AIRWORTHINESS DIRECTIVE

Ref. No. 2019-322-03

Applicability – RRJ-95 aircraft

Pursuant to revealing of the slat section track link crack on RRJ-95 aircraft,

Fig.1

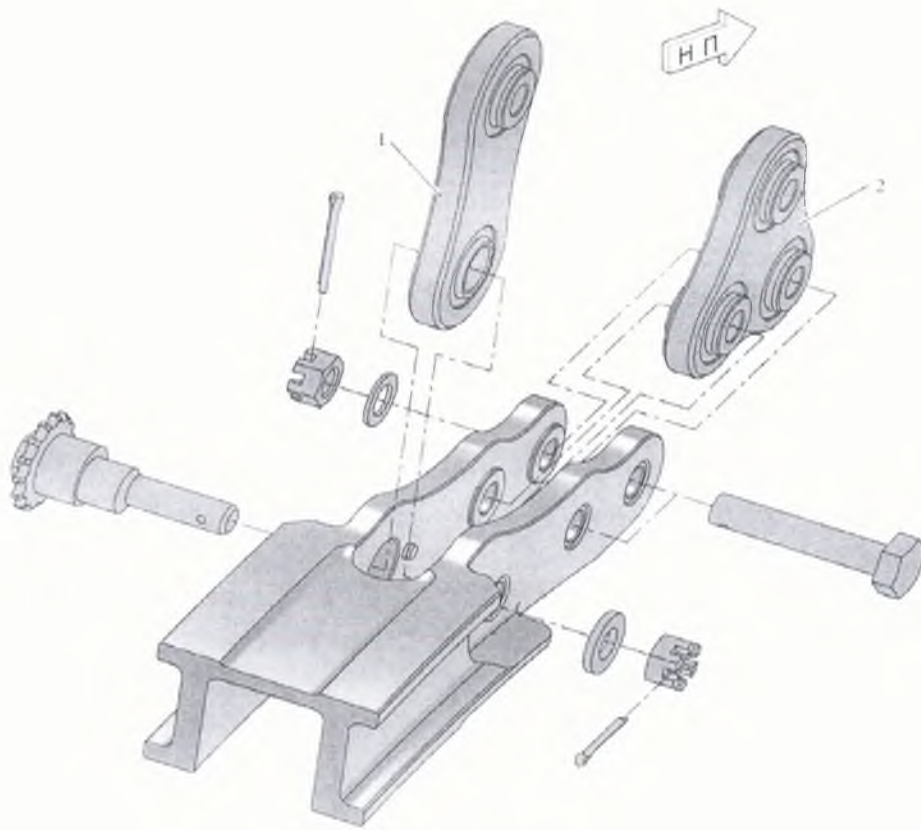
1. Starting from 15.06.2019, during the weekly WY-Check/8 DY on A/C RRJ-95 MSN 95030, 95037 and from 95116 to 95220, to perform the inspections of links of tracks (See. Fig.1 (it. 1, 2) and Fig.2 (it. 3) and bearings of links of track of sections 2, 3 and 4 of slat of LH and RH outer wings in accordance with the provisions of p. 4. Б. (2) and (6) of AMM Tasks No. 57-43-00-220-802, 57-44-00-220-802 and 57-45-00-220-802, until the implementation of SB No. RRJ-57-00451-BD “Wing – Replacement of link of track of slat section” (Planned release date of the SB – 23.05.2019г.)

2. In case of finding a crack of link of track and/or deterioration and press-out of the bearing of link of track of sections 2, 3 and 4 of slat of LH and RH outer wings following the results of implementation of p.1 hereof, it is necessary to replace the damaged track link assembly (track link and bearing), according to the identification information in Table 1 and under the instructions given in AMM Tasks No. 57-43-00-900-804, 57-44-00-900-804 and 57-45-00-900-804

Once the track link assembly is replaced, continue the inspections of the track links (See Fig.1 (items 1, 2) and Fig.2 (item 3) and the bearings of links of track of sections 2, 3 and 4 of slat of LH and RH outer wings during the weekly WY-Check/8 DY in accordance with the provisions of p.1 hereof and subject to the following conditions:
